**REFERENCE: GARVAN ST VINCENTS CAMPUS CANCER CENTRE
VICTORIA STREET CAFÉ 368 - 382 VICTORIA STREET,
DARLINGHURST - BCA COMPLIANCE STATEMENT**

In accordance with your instructions Blackett Maguire + Goldsmith Pty Ltd (BM+G) has reviewed the plans associated with the proposed new café fitout within level 4 of the newly erected Garvan St Vincent's Campus Cancer Centre, Darlinghurst.

The architectural drawings are illustrated below:-

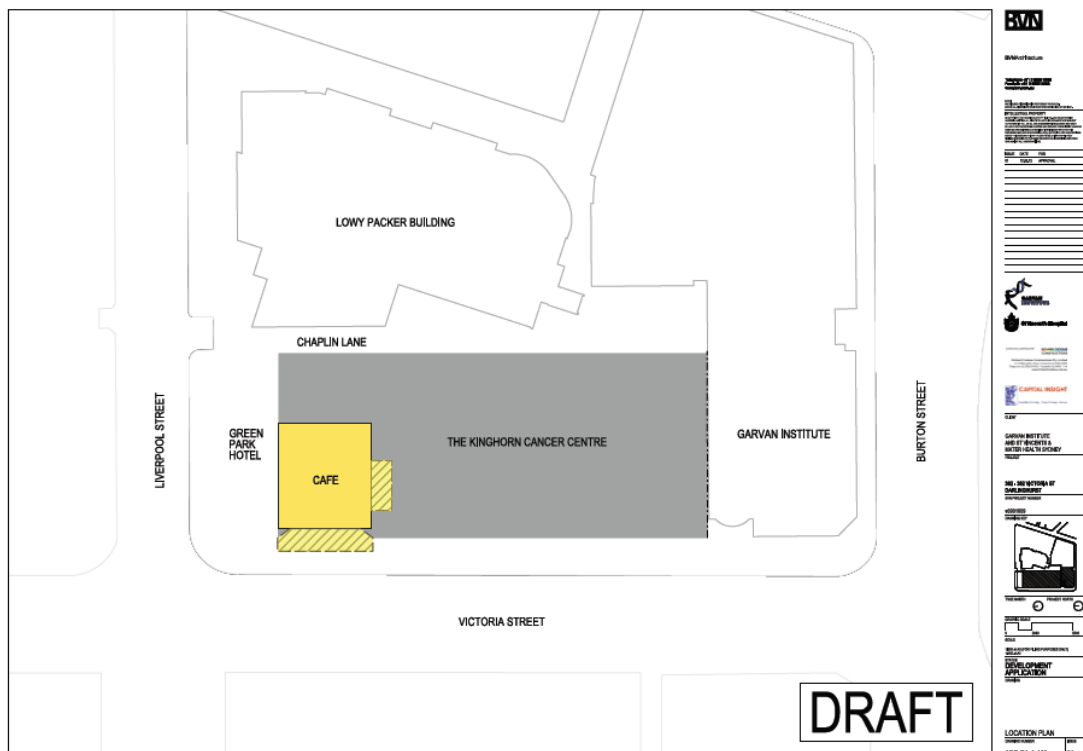
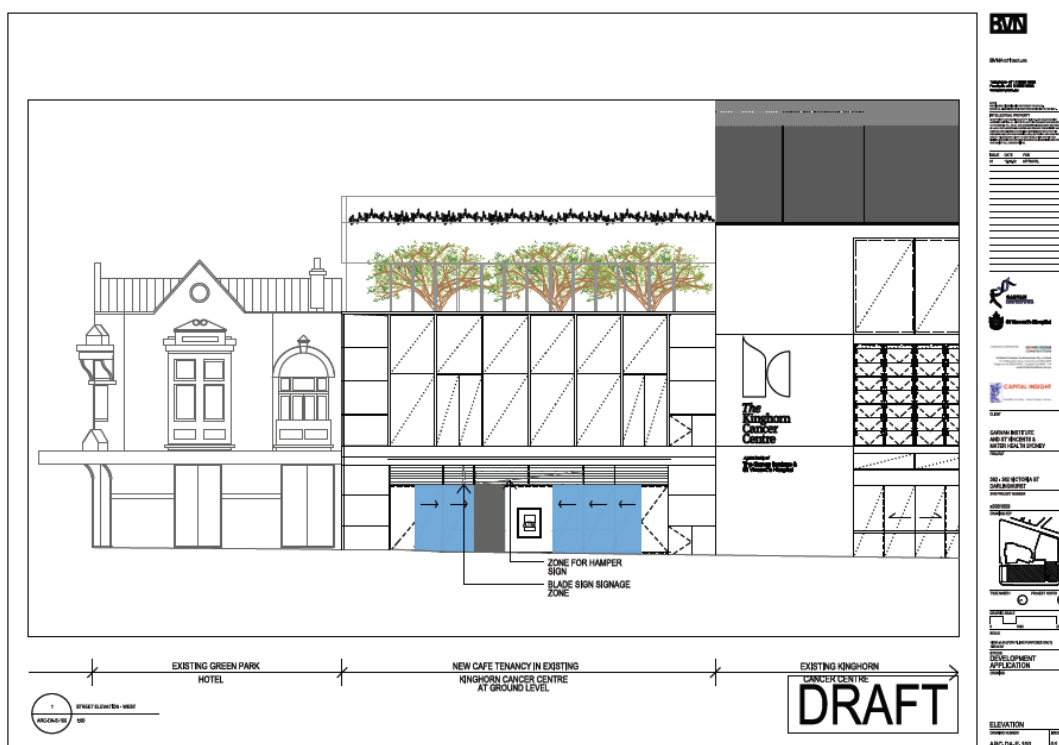
Arising from our review we are satisfied the proposed fitout of the level 4 café is capable of complying with the BCA2012 and the Access to Premises Standards 2010.

The design documentation will be further refined to ensure detailed compliance is achieved at the Construction Certificate stage, however we are of the opinion that such detail refinement will not give rise to any inconsistency with the DA-approved documentation.
